**Proposed 'Government Use' (GBA Air Quality Laboratory and
Meteorological Monitoring Supersite and Associated Filling of Land)
in "Green Belt" Zone and Area shown as 'Road',
Government Land in D.D.129, Deep Bay Road, Tsim Bei Tsui,
Yuen Long, New Territories
(Section 16 Planning Application No. A/YL-LFS/592)
- Further Information No. 4 -**

(S.16 Planning Application No. A/YL-LFS/592)

Comments Forwarded from Tuen Mun and Yuen Long West District Planning Office

**DRAINAGE PROPOSAL
FOR
PLANNING APPLICATION FOR
GREATER BAY AREA AIR QUALITY LABORATORY
AND METEOROLOGICAL MONITORING SUPERSITE
AT TSIM BEI TSUI**

DRAWING TITLE :
PROPOSED STORMWATER SECTION

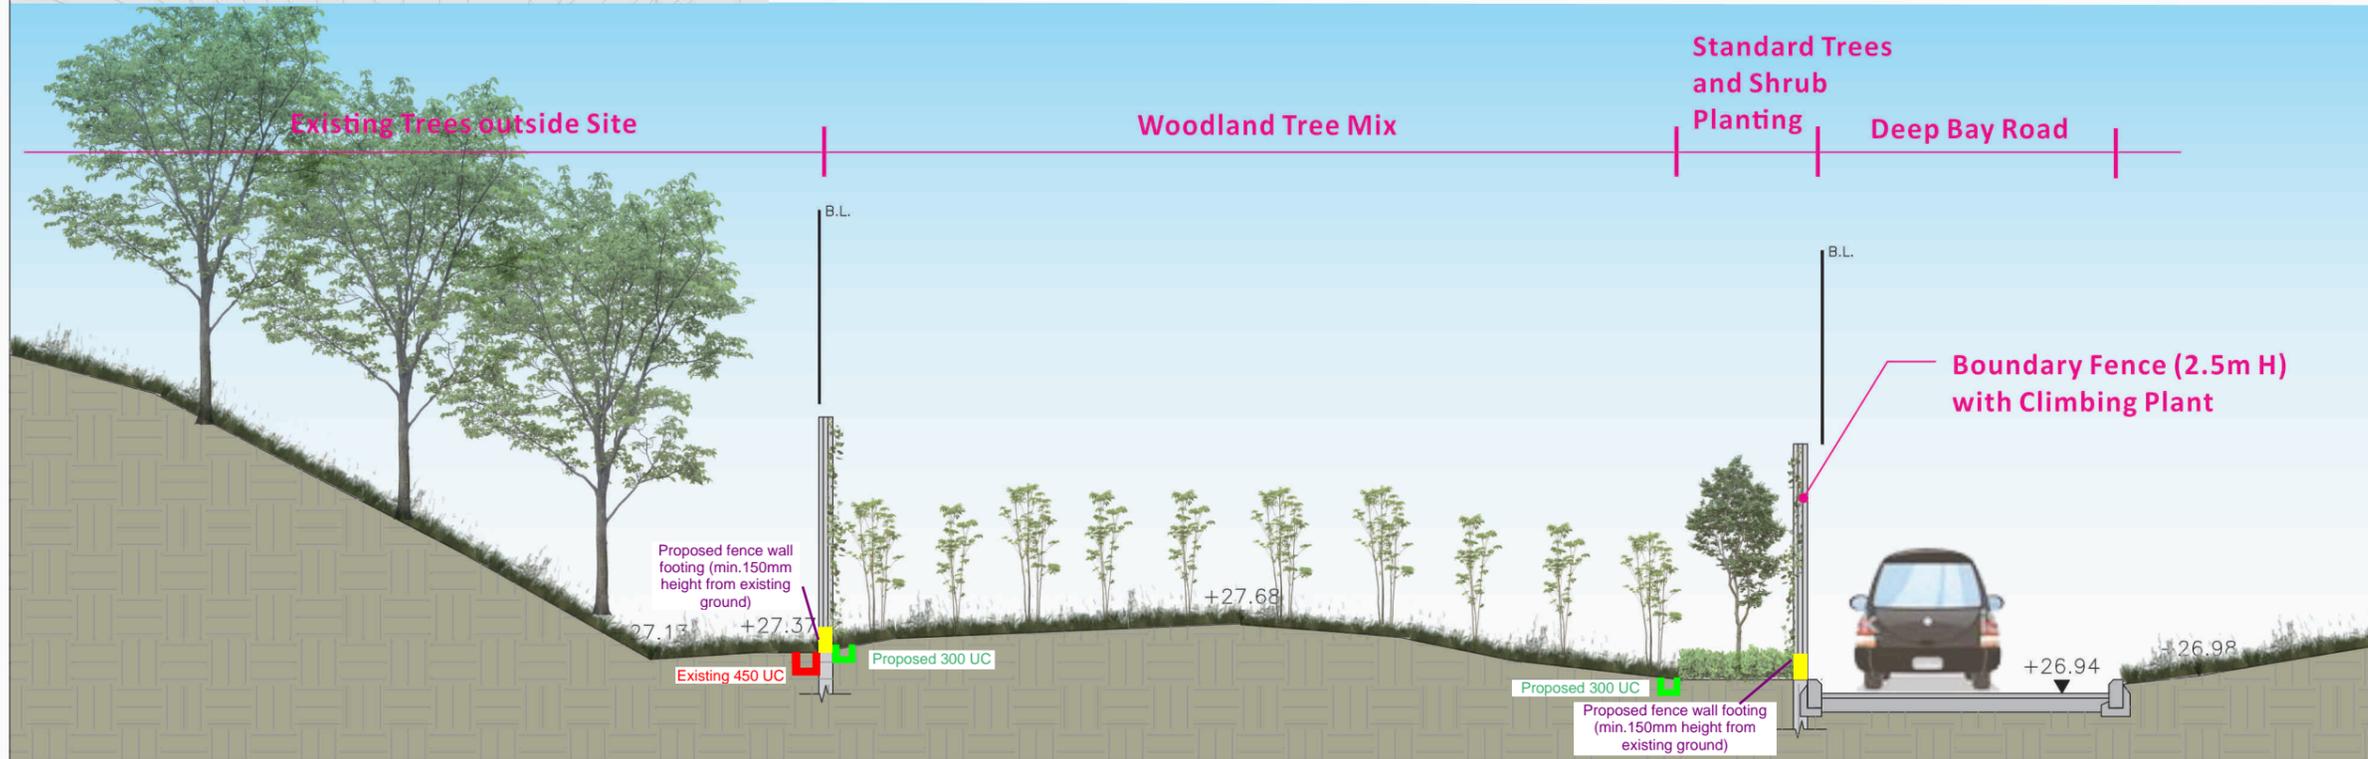
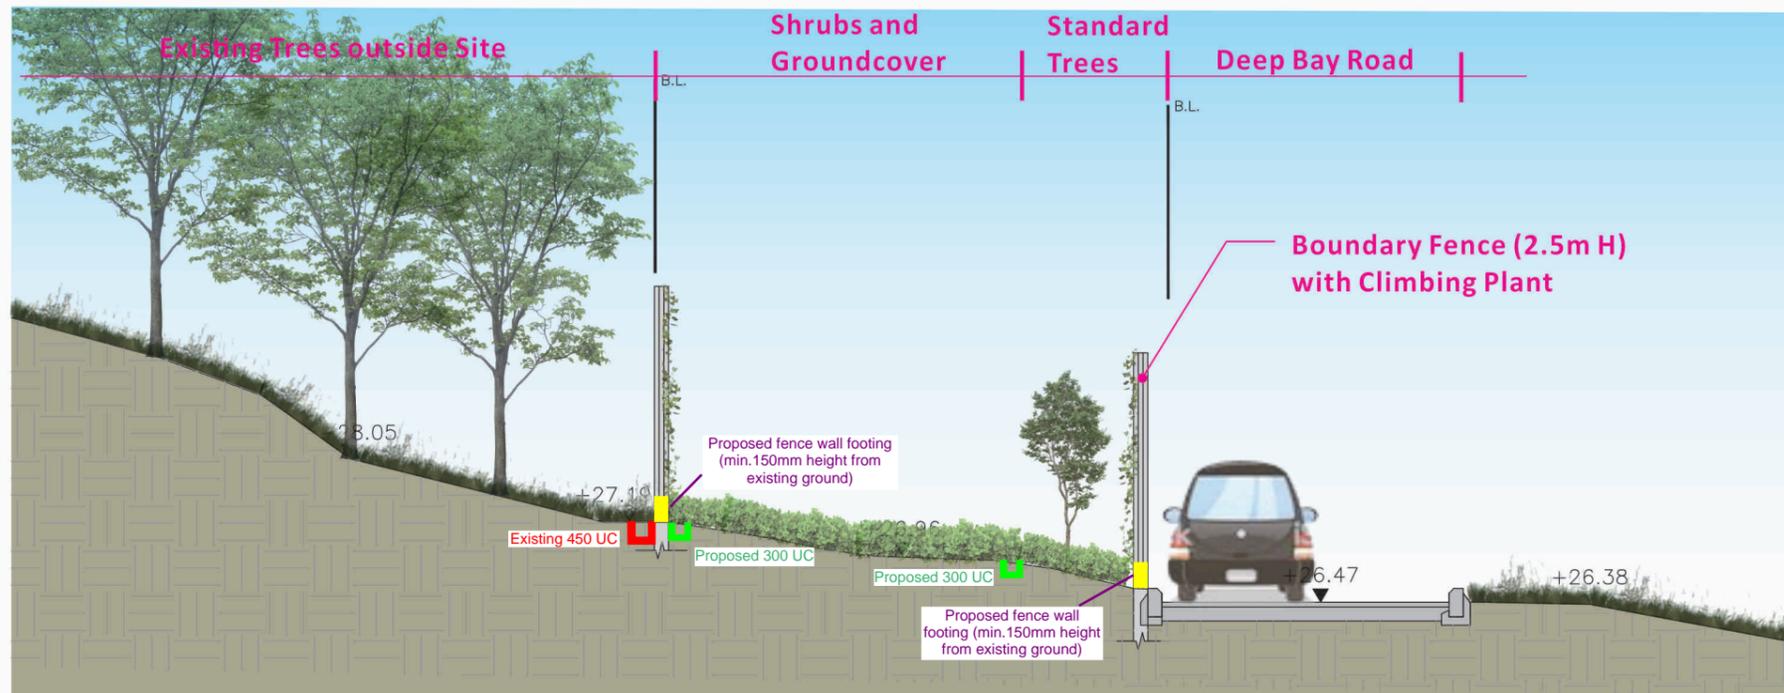
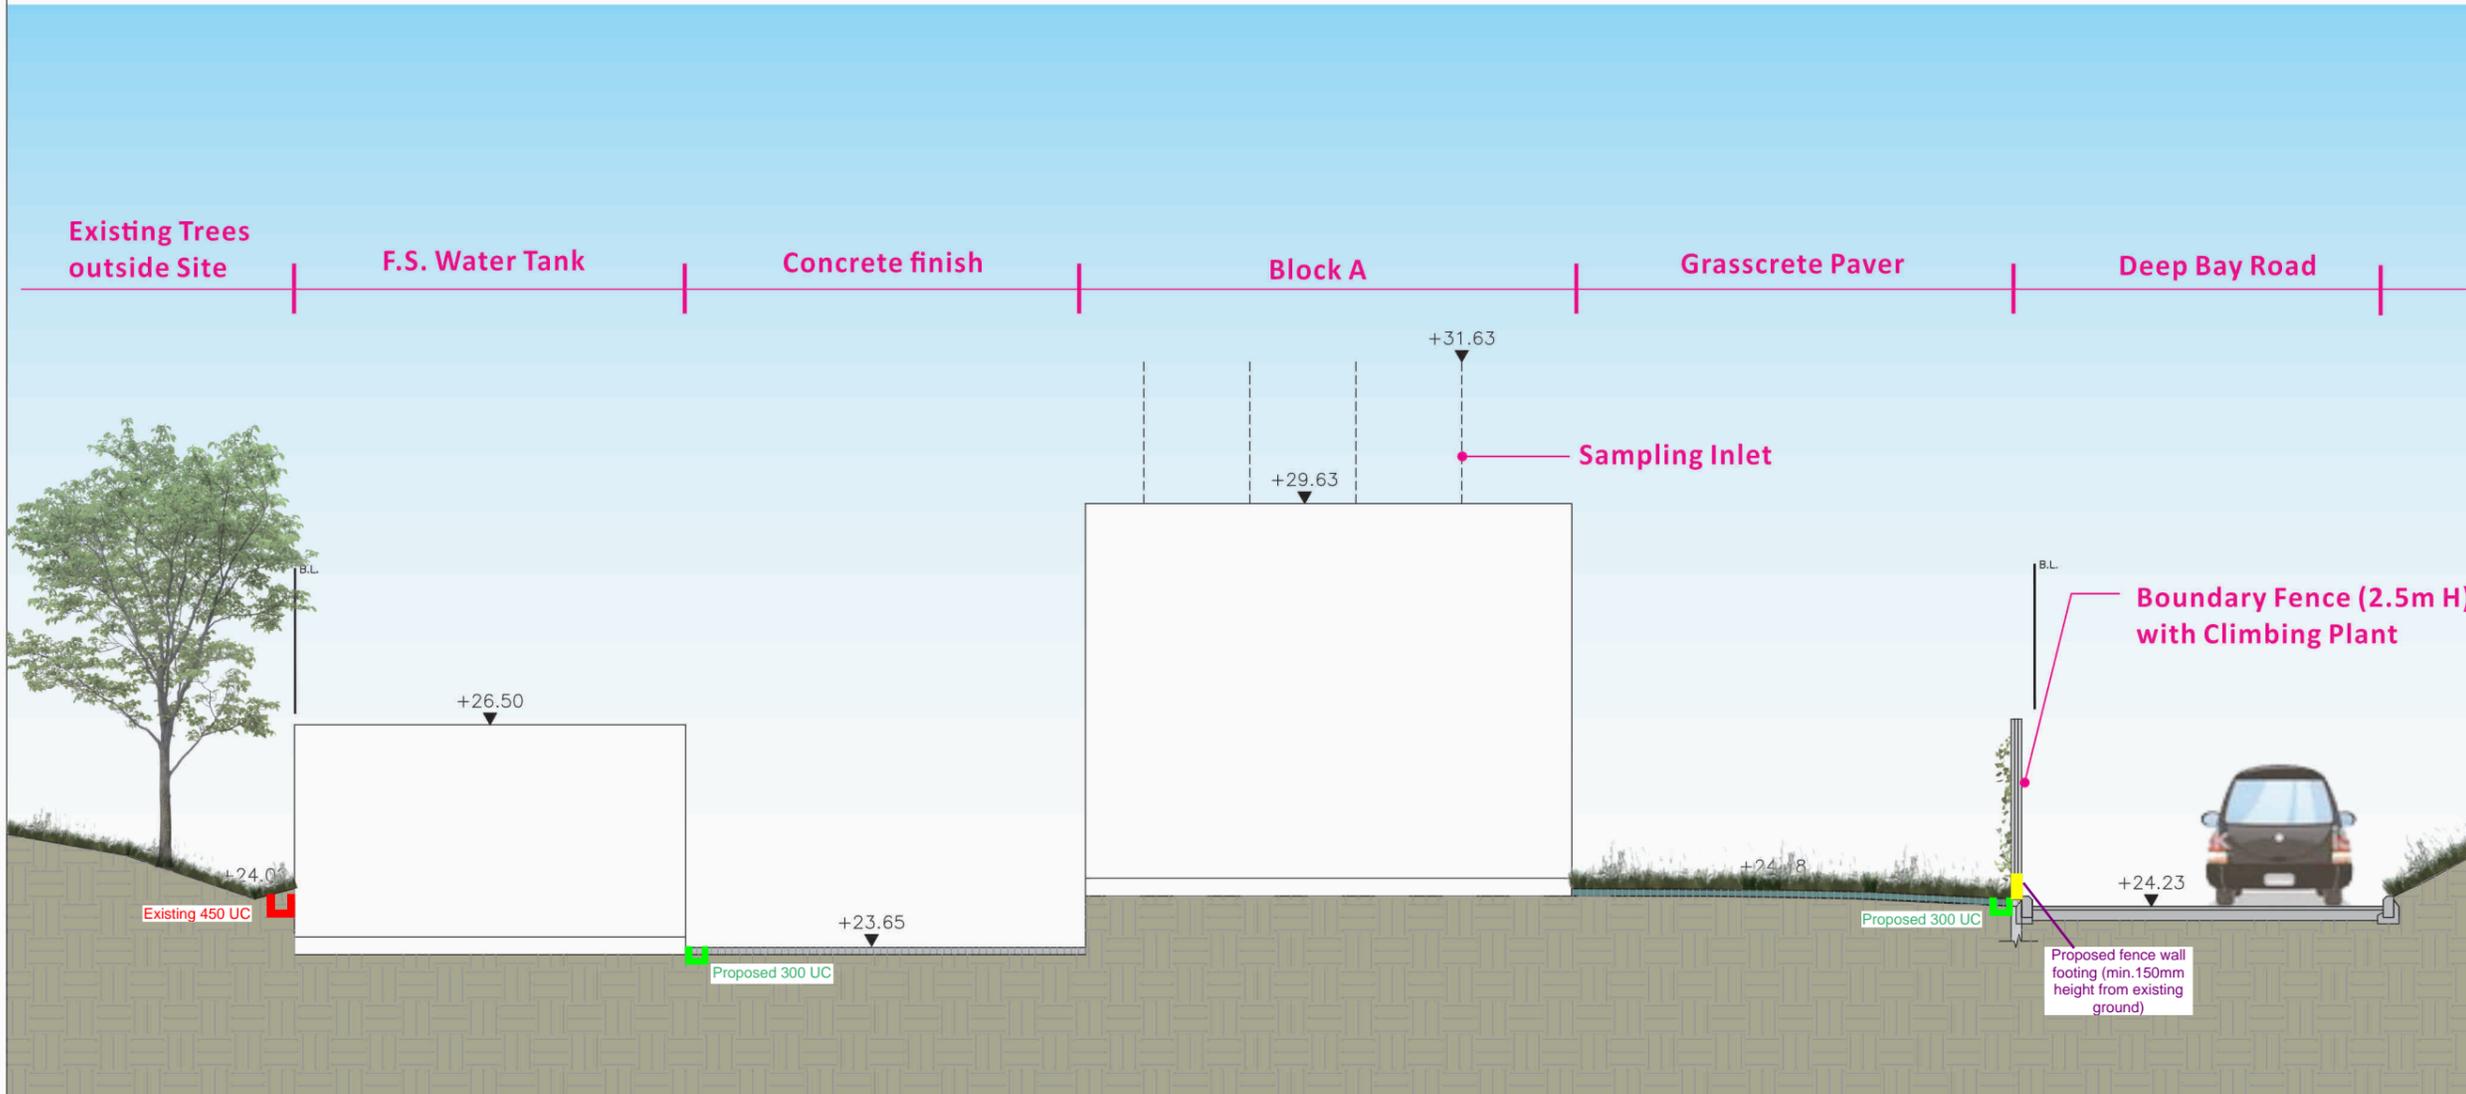
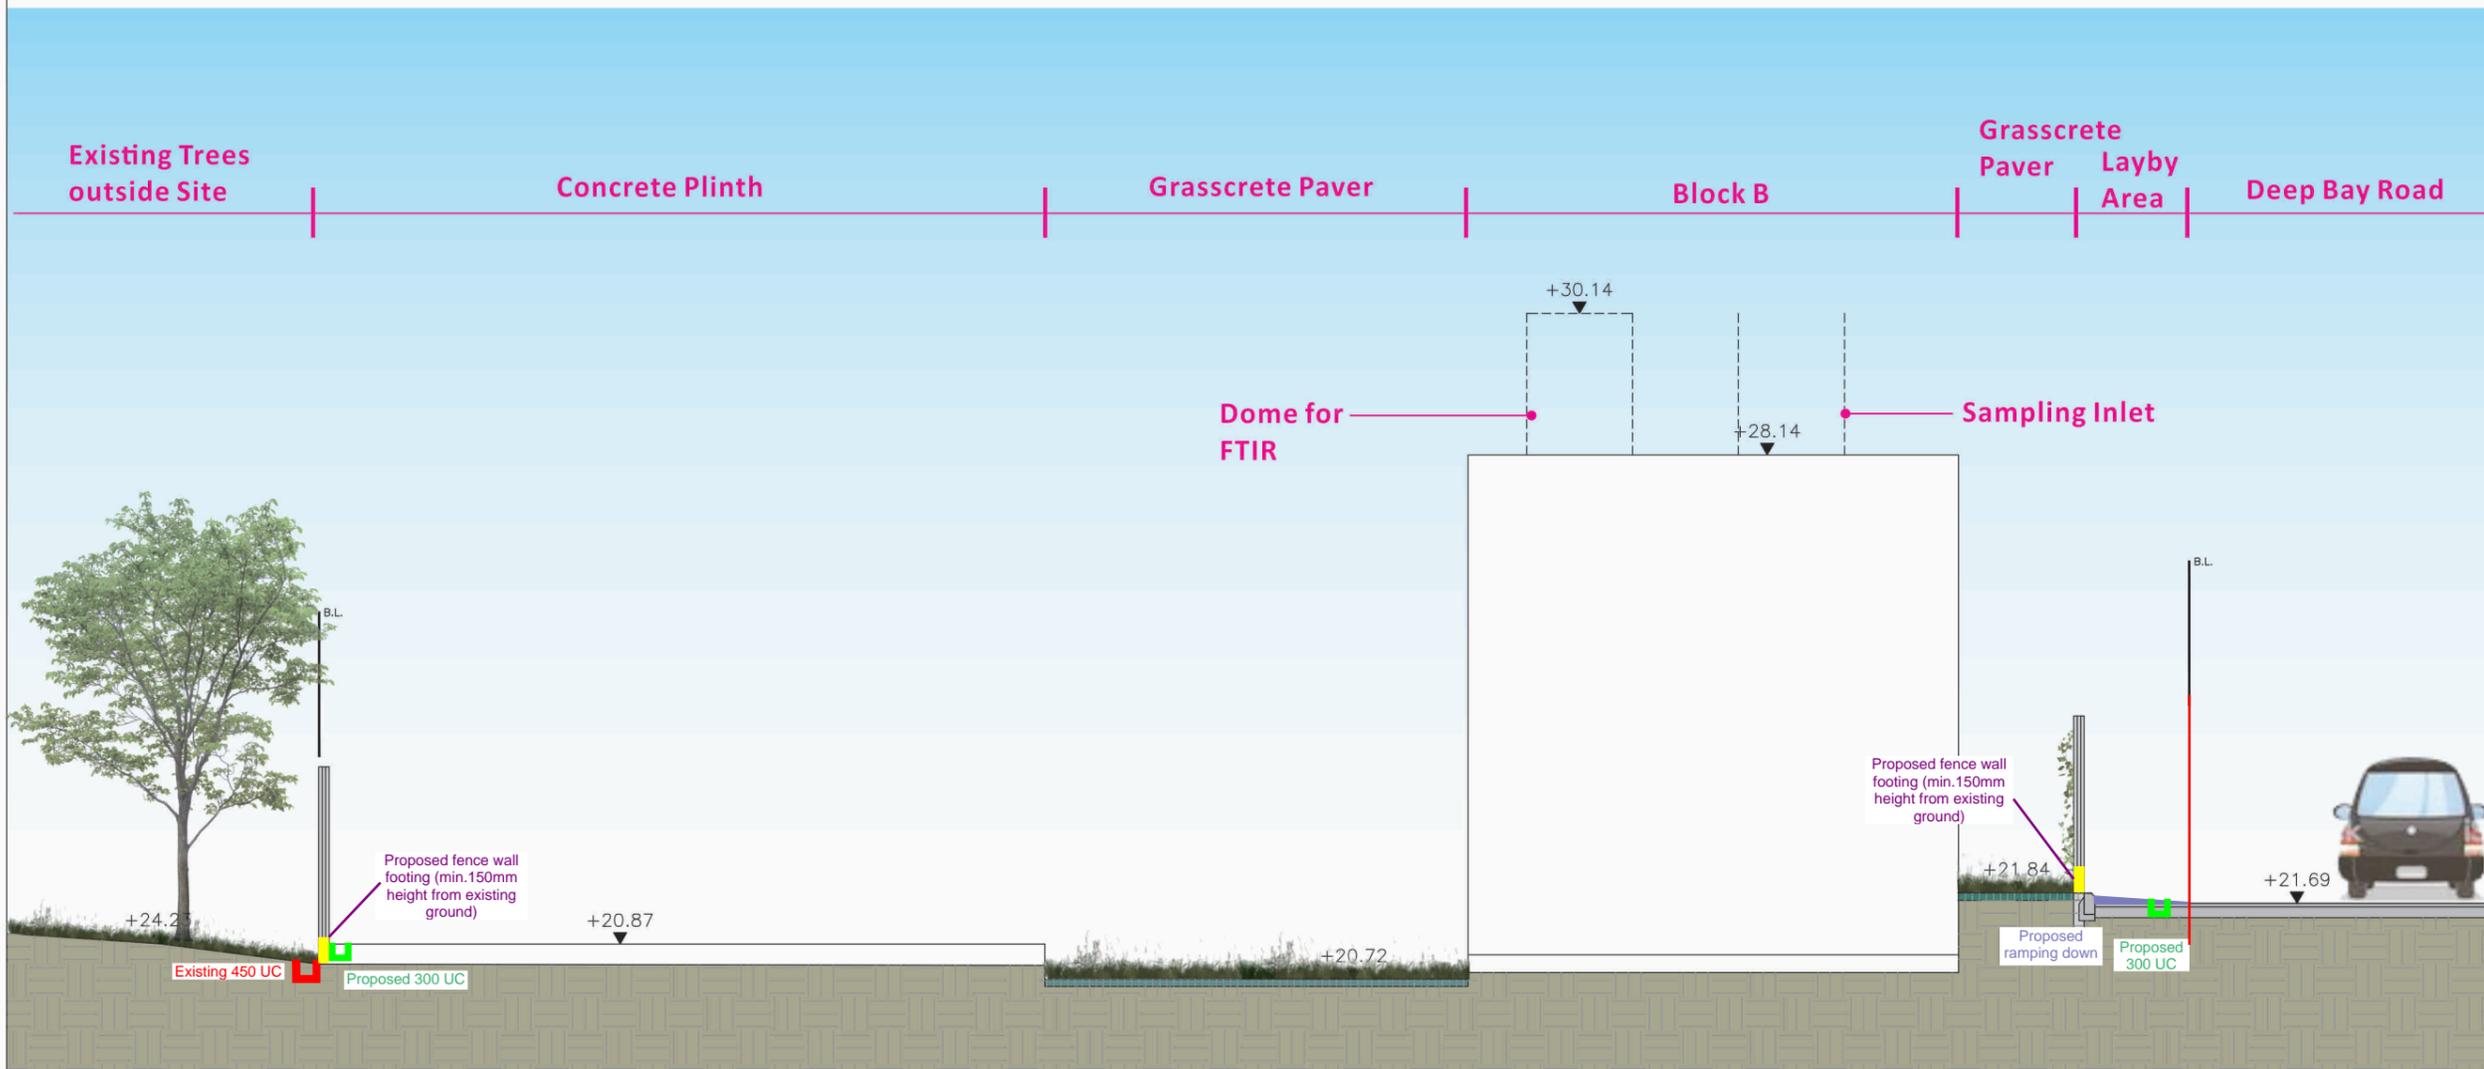
<p>(c) All proposed fencing/ wall, size/ provision of existing and proposed drains should be shown on cross sections.</p>	<p>The design sections indicating proposed fence wall, proposed ramp, existing and proposed drains are included in Appendix G of the Drainage Proposal.</p>
<p>(d) The development should neither obstruct overland flow nor adversely affect existing natural streams, village drains, ditches and the adjacent areas, etc.</p>	<p>Noted. The proposed development will not be adversely affected the drainage in close proximity.</p>
<p>Despite of the above, I have no objection in principle to the proposed development from the public drainage point of view. For any change of existing ground level and associated works proposed by the applicant that could affect adjacent land and cause other impacts and/or other issues to public, please consider to require the applicant to submit technical assessment(s) in other aspect(s) and seek comment from relevant departments as necessary. Should the Town Planning Board consider that the application is acceptable from the planning point of view, conditions</p>	<p>Noted with thanks.</p>
